SITE PLAN
 BRIDGE NO. CUY-10-0869
 OVER VALLEY PARKWAY AND ROCKY RIVER

CUY-480-6.47 /
VAR PAINT
PID No. 22131

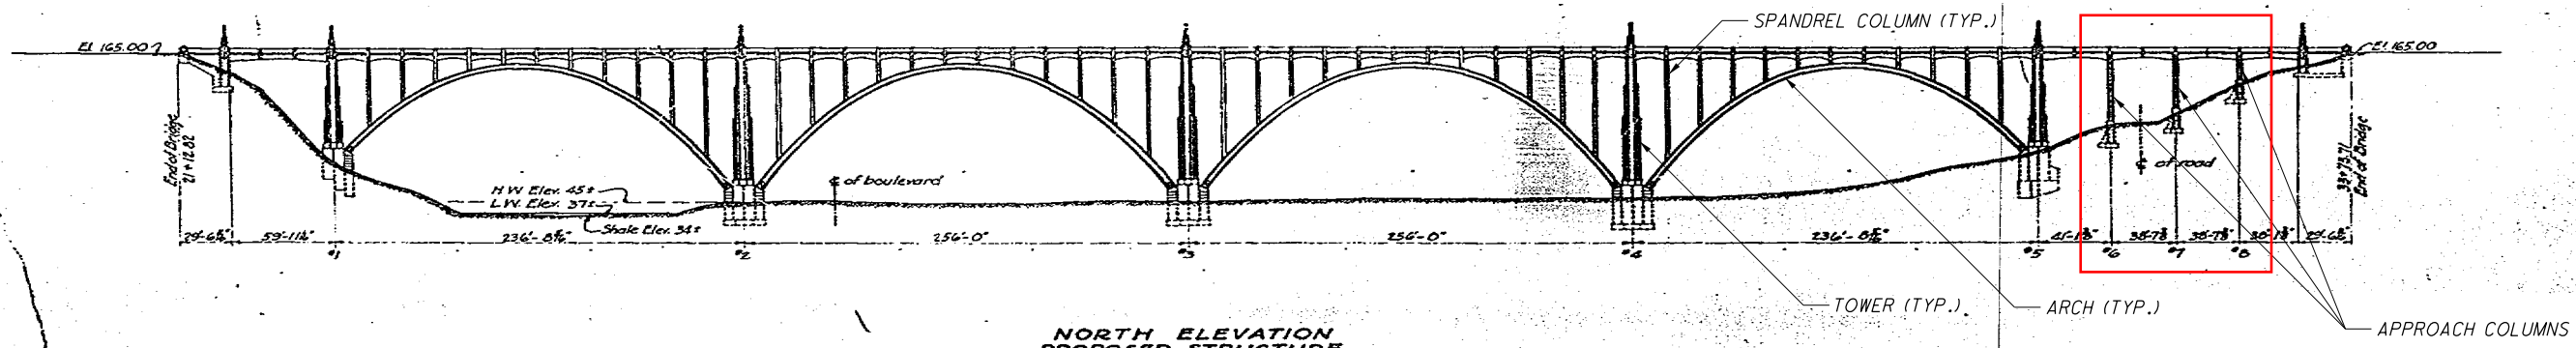
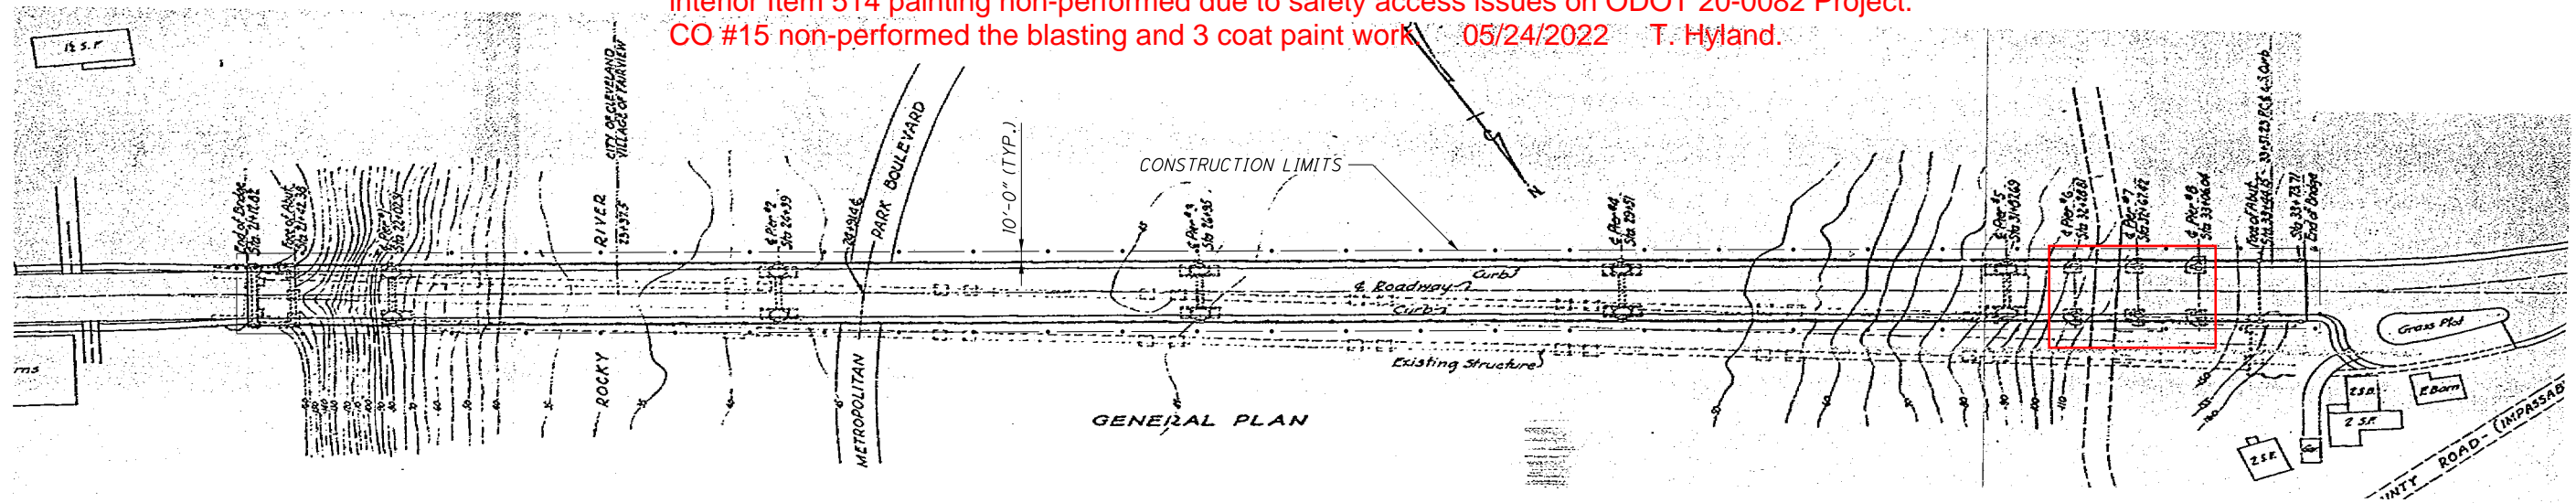
These 6 columns on the west approach to the Lorain Road Bridge Arch over the Rocky River had their interior Item 514 painting non-performed due to safety access issues on ODOT 20-0082 Project. CO #15 non-performed the blasting and 3 coat paint work. 05/24/2022 T. Hyland.
